City of Tacoma

Questions and Answers No. 2

North End Treatment Plant Trickling Filter Upgrade RFB Specification No. ES25-0058F

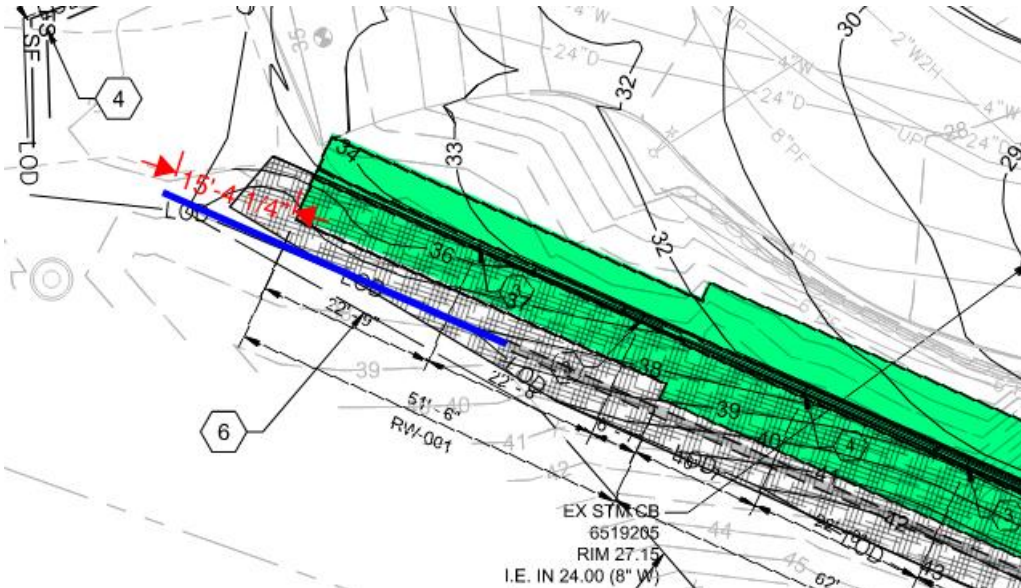
- 10. Question: Drawing C-0-40 shows two cast-in-place wing walls on either side of the shoring around the trickling filter. Wing walls are not detailed anywhere except the small section above the existing wall per D/S-4100-06. Please advise if cast-in-place wings are needed and if so, please provide details.**

Answer: CIP wings are not needed at that location - permanent shoring wall is constant up until connection point (per Structural detail). Callout should be removed.
